GJS Plot F, Manchester

Non-material Amendment | 23.08.2024

Z1-SHP-A180-RP-XX-NMA02 | P02

Updated Proposal - F1-SHP-G200-PL-Grd-B5D801 - P04

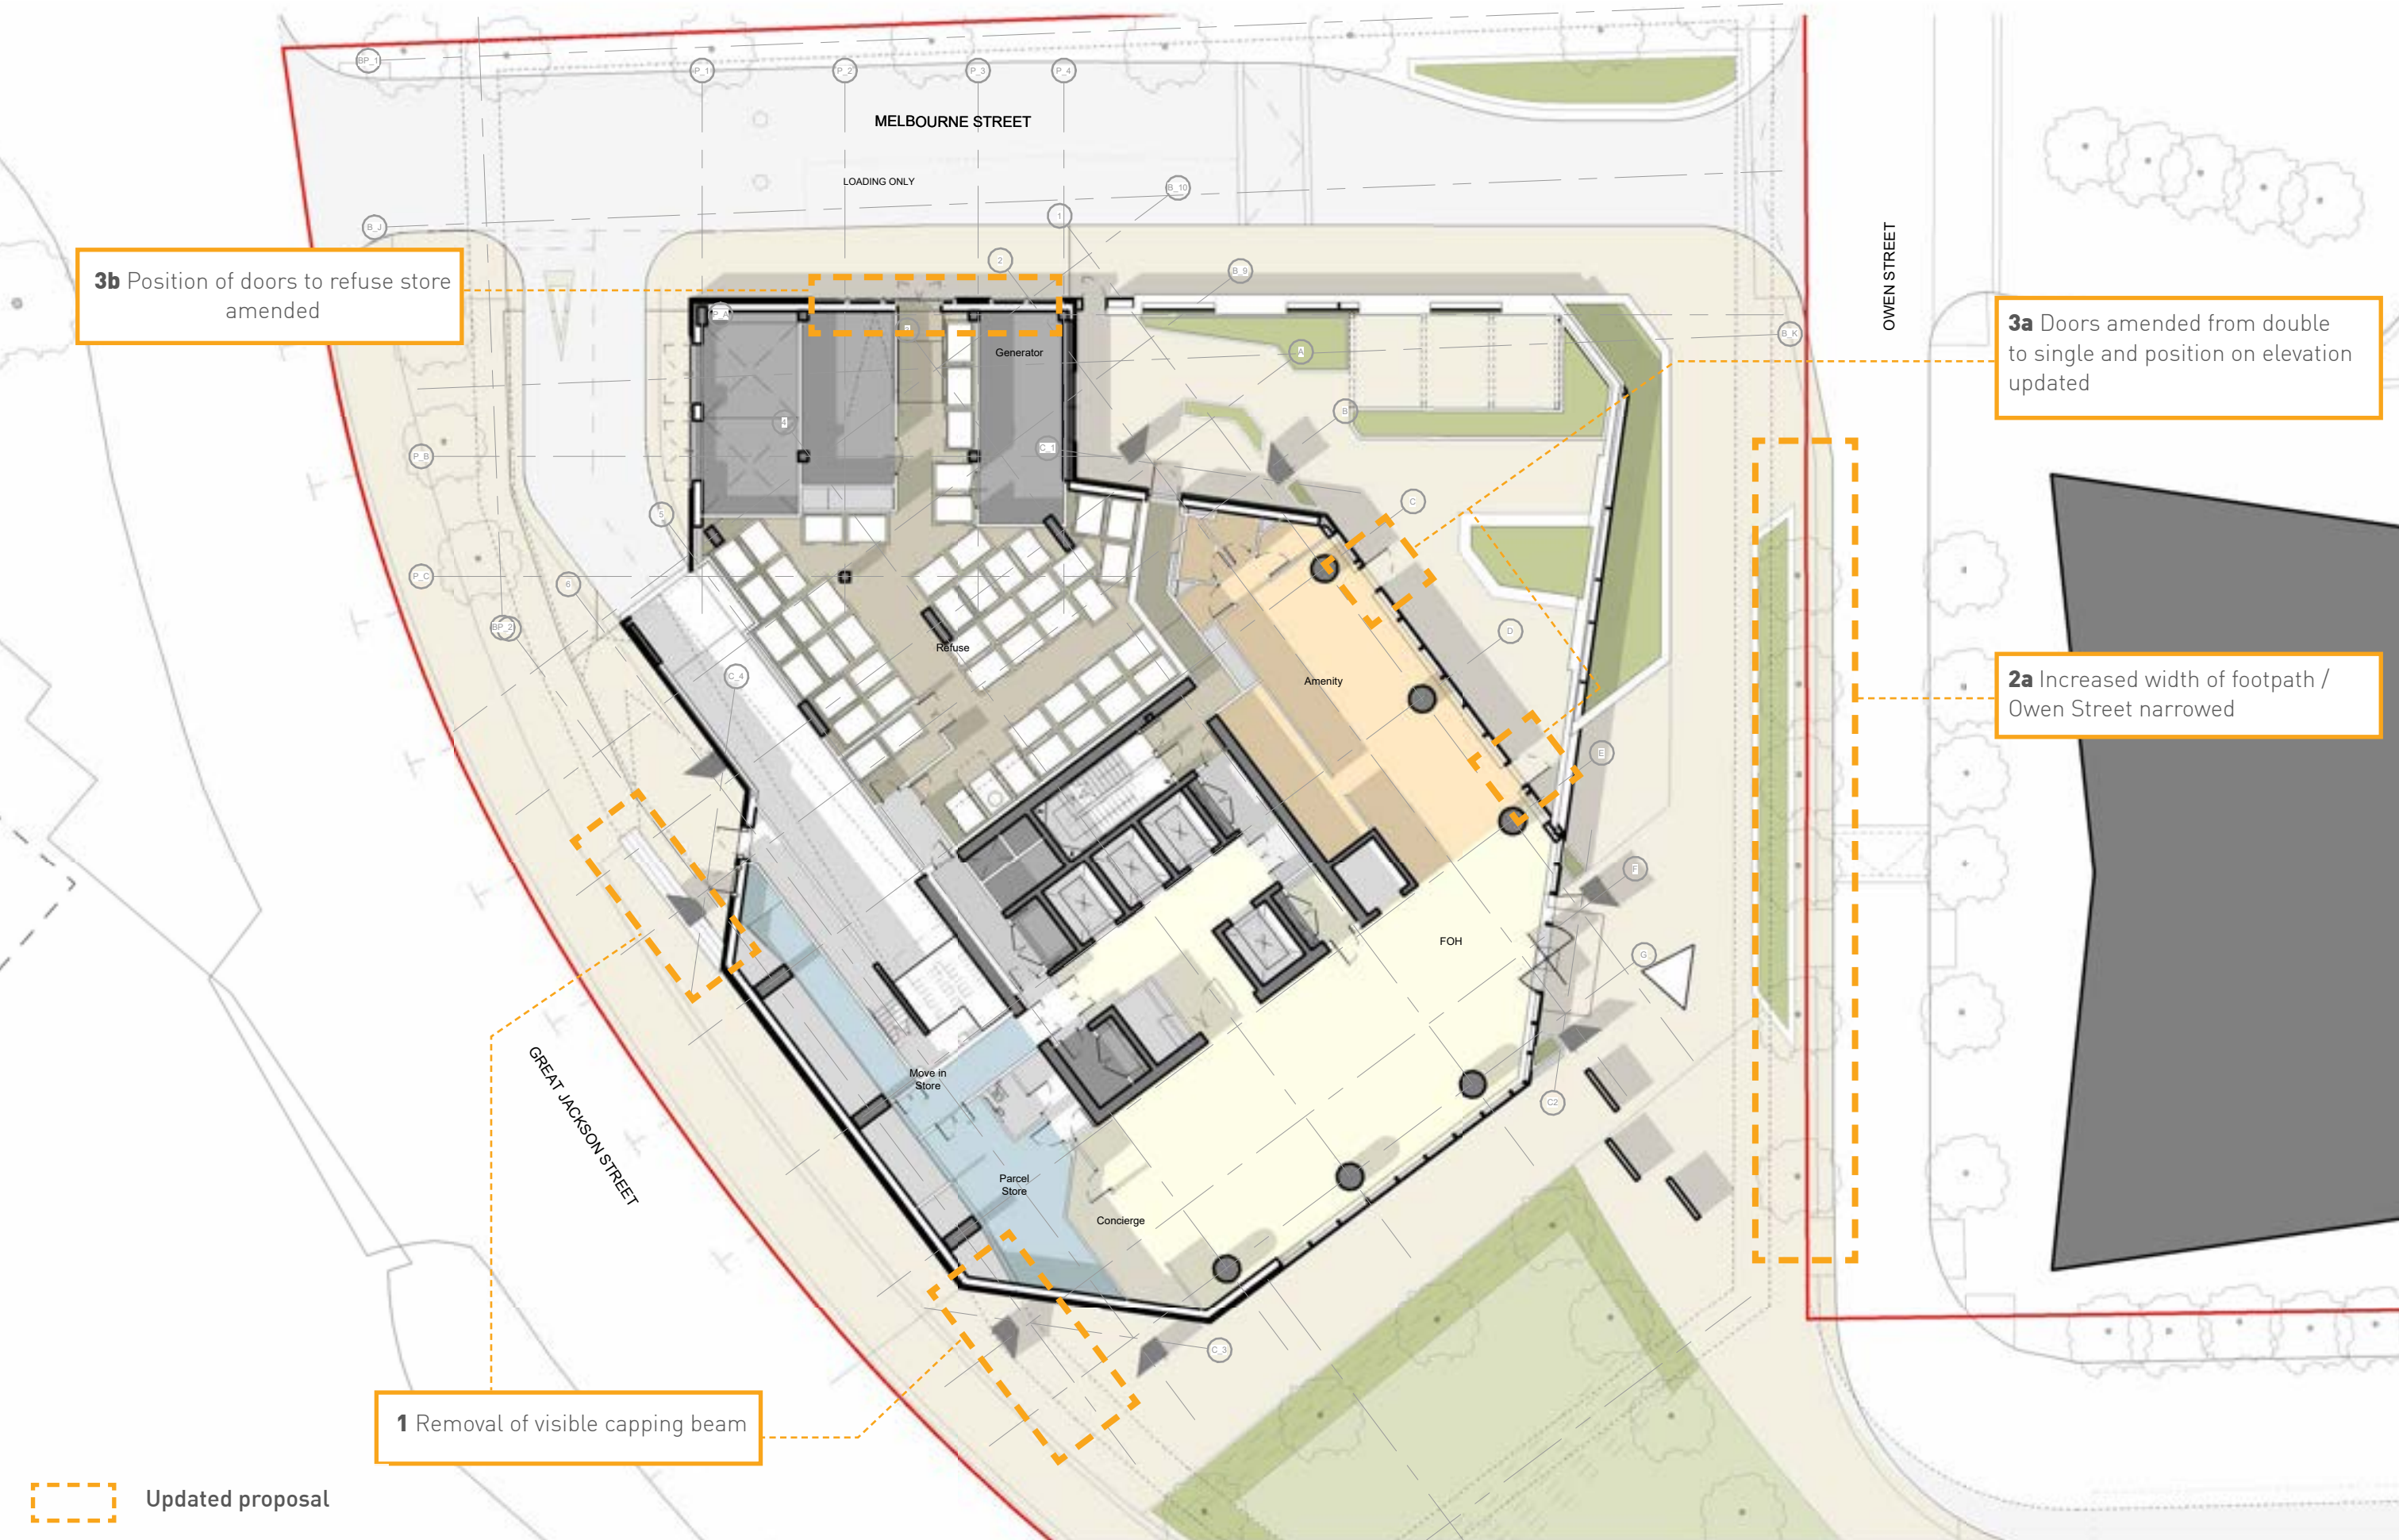
Tower F1 - Removal of visible capping beam along Great Jackson Street

At planning stage it was deemed necessary to keep the capping beam (top of the basement piled wall) above ground level, due to the proximity of the F1 capping beam to the pavement.

Through further structural design and refinement of temporary works, the design team have been able to lower the entirety of this structure so that it is not visible from street level, with the following benefits:

F1 - Doors to refuse store / car park smoke extract

Due to the incorporation of the perforated screen in front of the car park extract louvres (as requested by MCC) on F1, it has been necessary to revise the free area requirement for basement the car park extract system and adjust the door position to the refuse store accordingly.
- c.

Updated Proposal - F2-SHP-G200-PL-Grd-B5D801 - P05

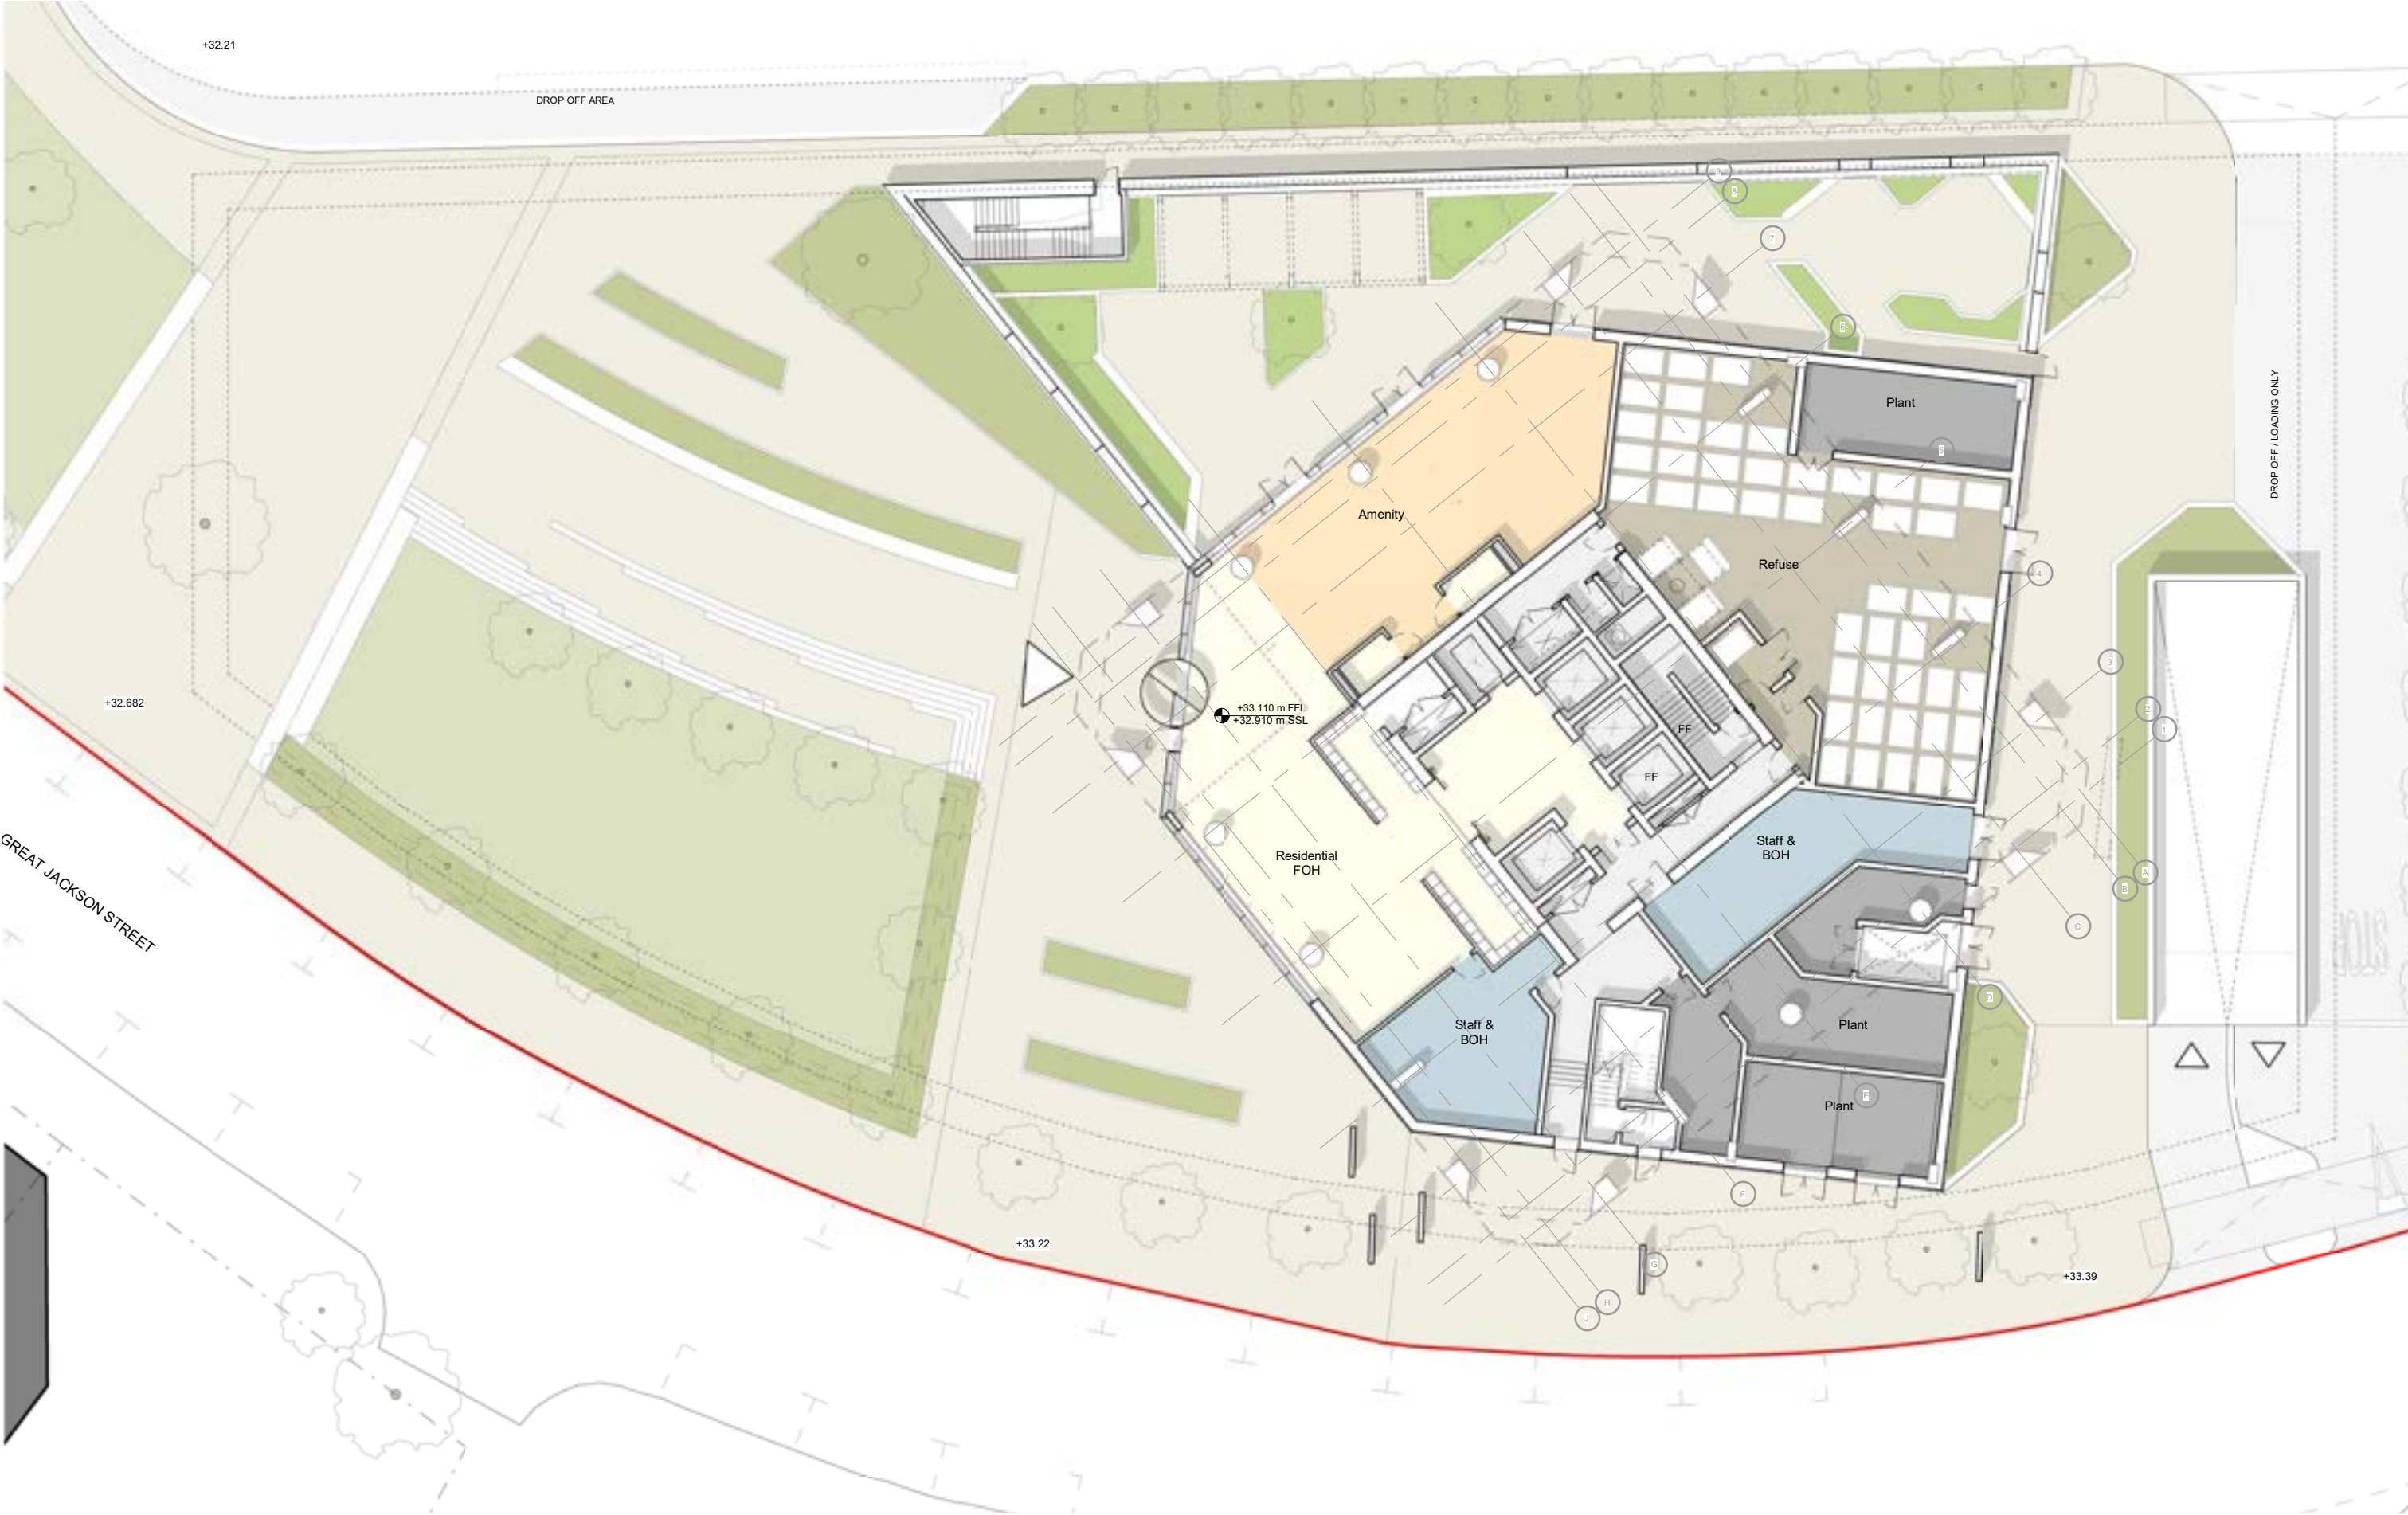
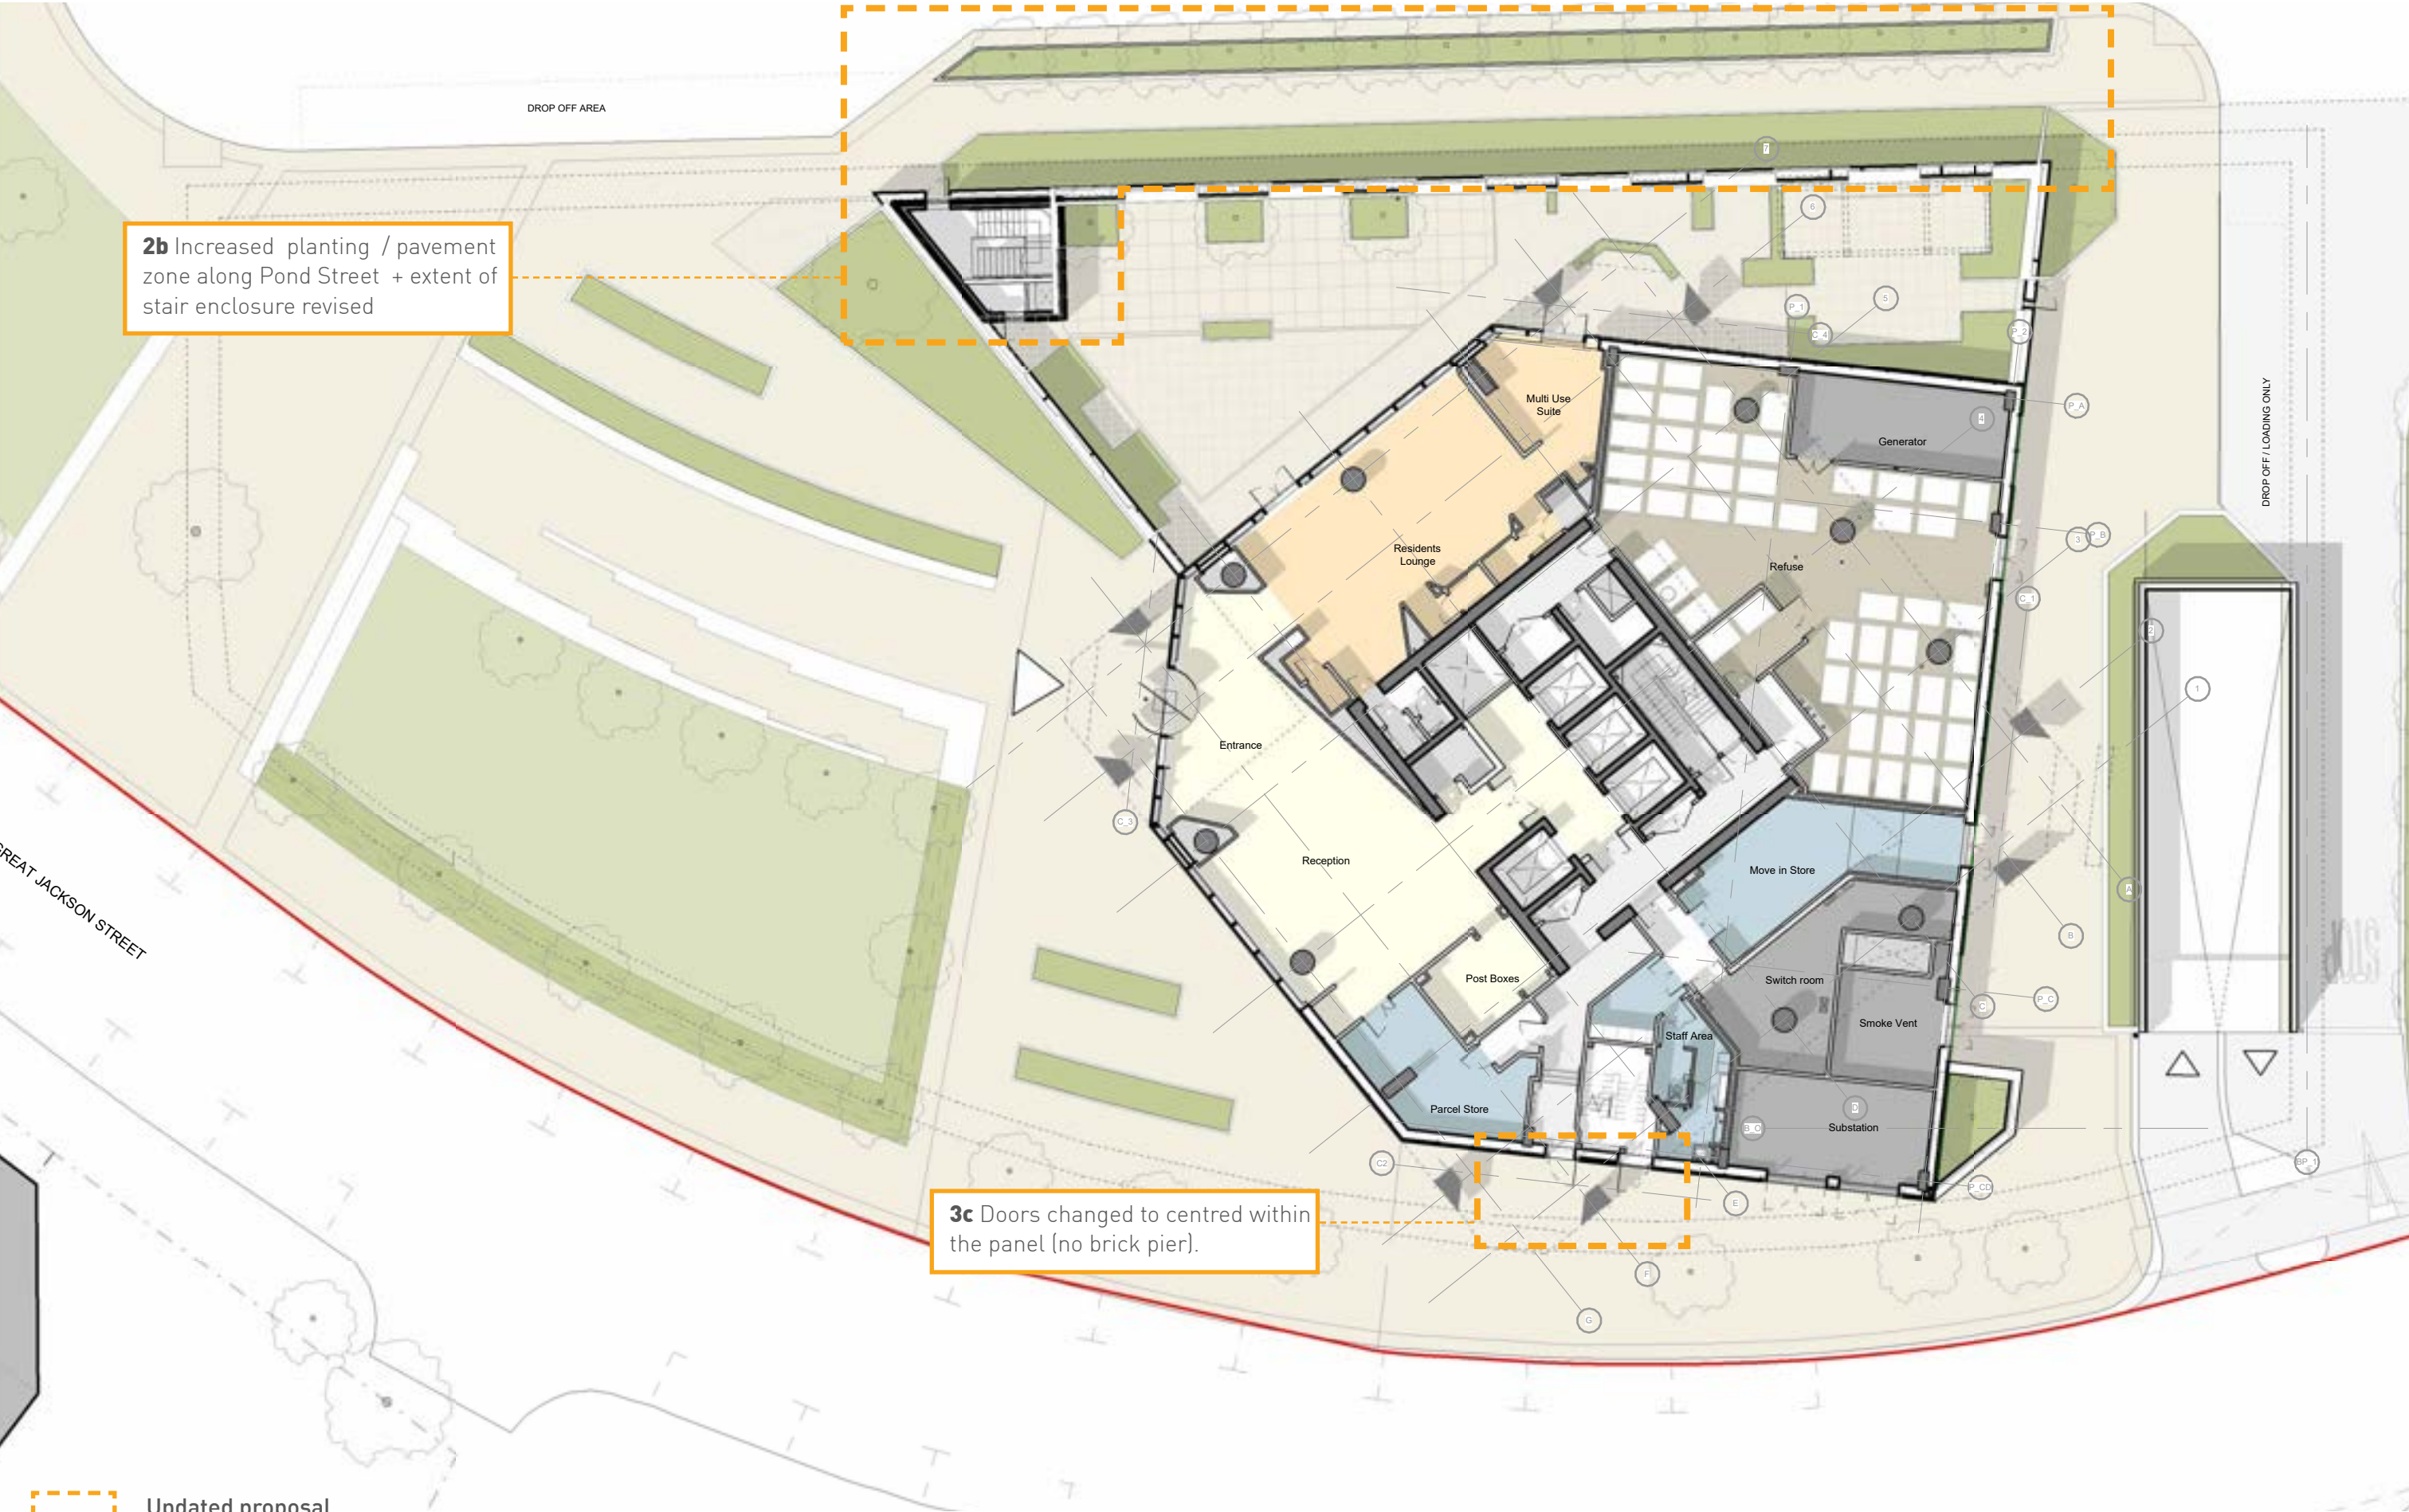
Tower F2 - Pond Street changes; raised boundary at the private garden and re configuration of the stair enclosure

The landscape boundary treatment to the pond street elevation of F2 has been reconfigured, allowing a greater landscaping zone and wider footpath.

Additionally the standalone escape stair that forms part of the F2 garden wall has been reduced in length but increased in width slightly to accommodate a smoke extract shaft to the stair lobbies. The overall footprint is similar to that of the consented scheme.
4.
